寄件者: 陳灝然 [redacted]
寄件日期: 2026年11月04日星期三 11:21
收件者: [redacted]
主旨: A/YL-NSW/368進一步資料
附件: A-YL-NSM-368 Run-in out Proposal .pdf

Submission of a Run-in/out Proposal

Proposed Temporary Shop and Services (Vehicle Parts) and Public Vehicle Park (Private Car) with Ancillary Electric Vehicle Charging Facilities for a Period of 3 Years at Lot 1510 and Extension RP (Part) in D.D. 115 and Adjoining Government Land, Nam Sang Wai, Yuen Long, New Territories
(Application No. A/YL-NSW/368)

Appendix 6 & 7
Proposed Run-in/out Layout Plan

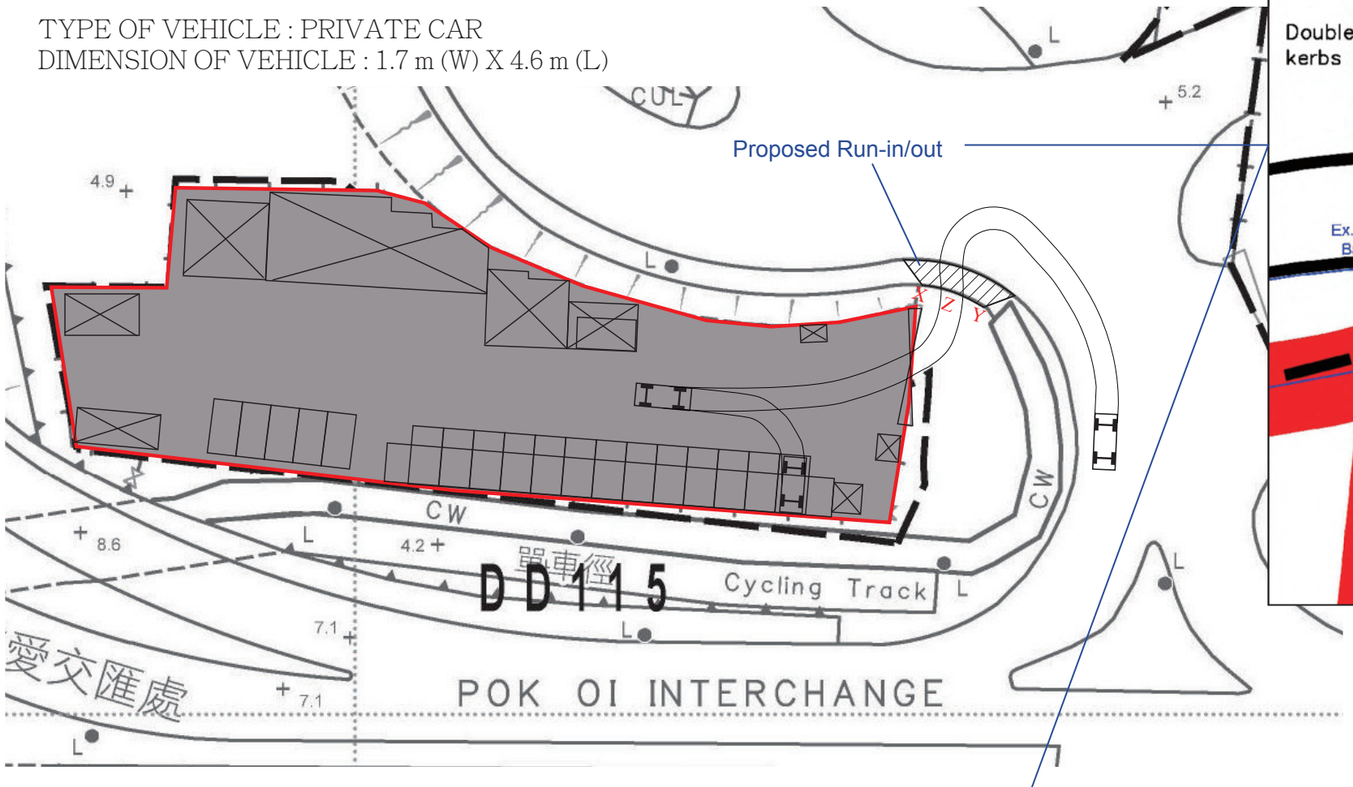
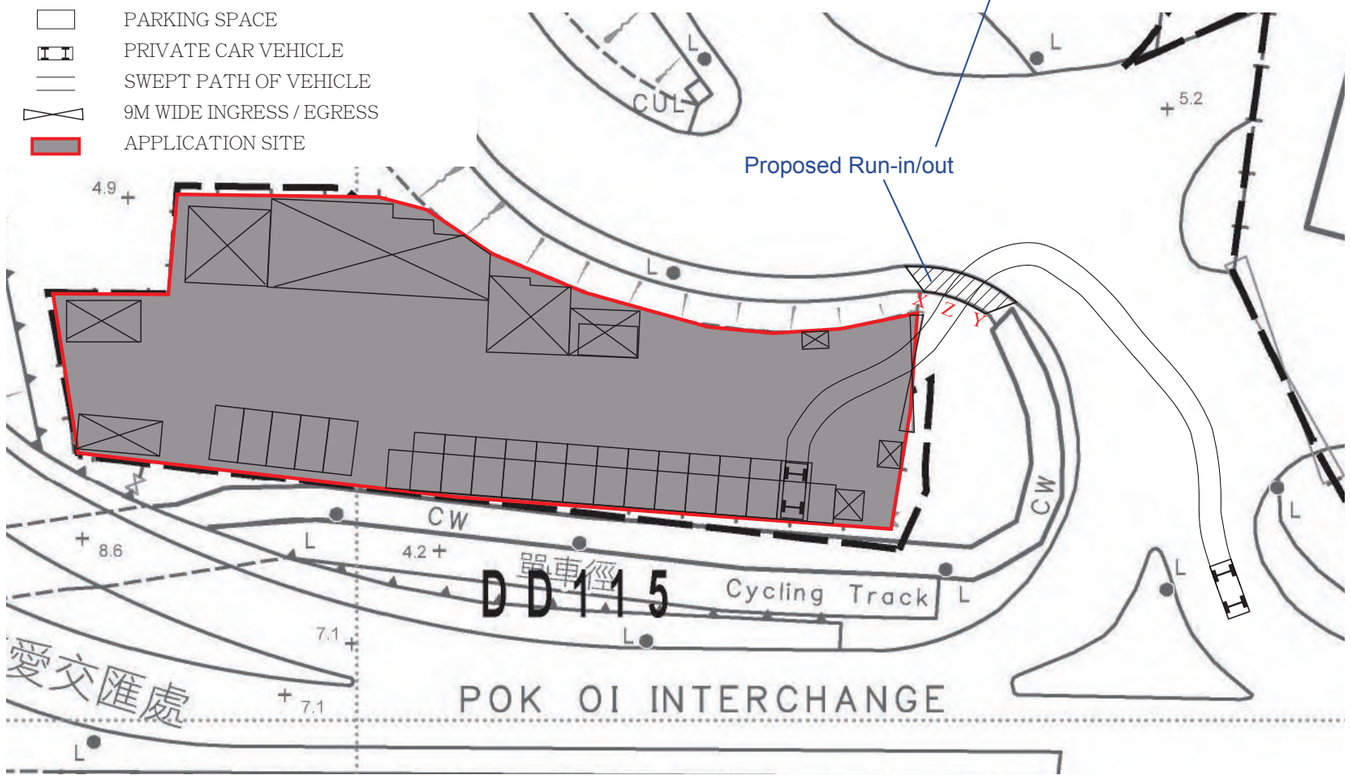
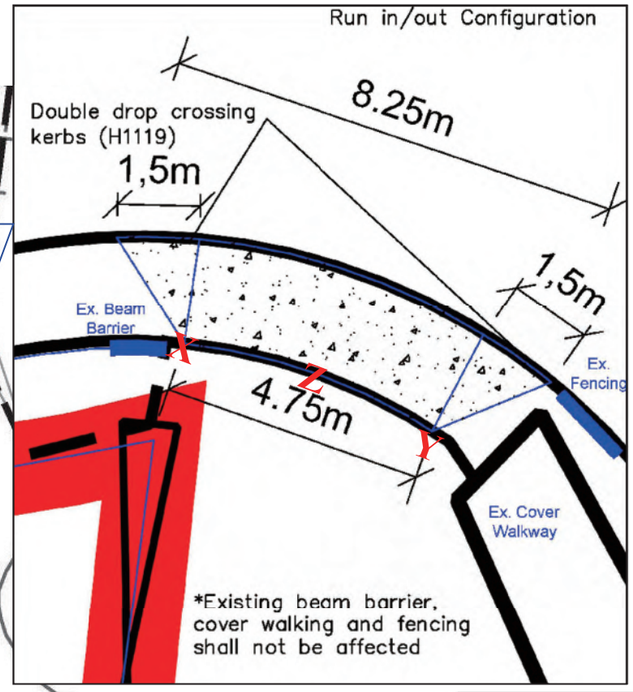
1. 車輛出入口及圖則標示： 關於圖則要求，我們已將車輛出入口的確切位置清晰標示於車輛轉彎半徑圖中，以符合相關審核標準。此外，就地盤車輛通道之坐標，申請人會與元朗地政處進行積極溝通，並將按地政處之要求落實最終位置。我們亦承諾未來車輛將嚴格限制於指定的 XYZ 點進出地盤，絕不允許從其他位置進出。
2. 行人安全與現場管理措施： 為確保公眾及行人安全，並避免行人難以辨識車輛出入口或行人路，我們將落實以下現場管理與交通指揮措施：
    - 於車輛進出時分派兩名專責職員在場協助，分別派駐於場內大門及對出馬路位置。
    - 現場職員將配備對講機以加強緊密配合、指揮車輛出入，全面協助停車場的日常營運及交通安全。

3.3 Drawing number R-01 (**Appendix 6**) shows the configuration of the proposed run in/out. The proposed run in/out does not affect the existing fence, cover walkway and beam barrier. It also shows the smooth manoeuvring of vehicles to/from Siu Sheung Road. Drawing number R-02 (**Appendix 7**) shows the smooth manoeuvring of vehicles entering/leaving the site.
